ED153 : NHDC Final response to Inspector's Actions Arising out of the Hearing Sessions

ED153: NHDC Note on Parking standards

North Hertfordshire district Council Local Plan Examination Note to the Inspector

Car Parking and Cycle Standards

Figure 1: Average Car Ownership with growth 2011 to 2031

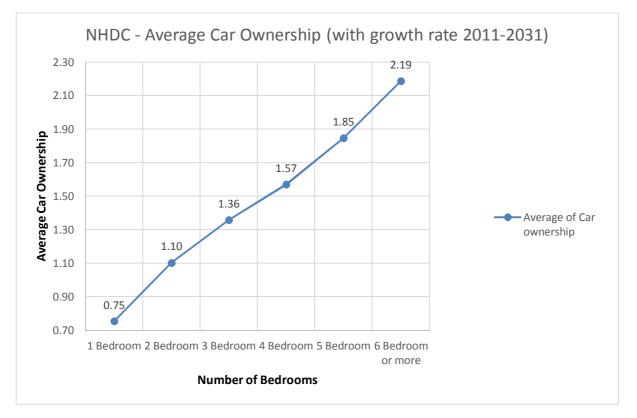
- 3.5 This growth rate has been applied to the average NHDC car ownership figures per size of dwelling, and the results are shown in Figure 1. This supports the conclusion that 1 bedroomed units require on average (rounded up) 1 parking space, while 2 bed roomed units and above require more than 1 parking space and is set at 2 parking spaces.

3.6 Figure 1 shows the estimated future average car ownership by bedrooms across NHDC. These averages include a wide range of dwelling types and locations, and clearly there will
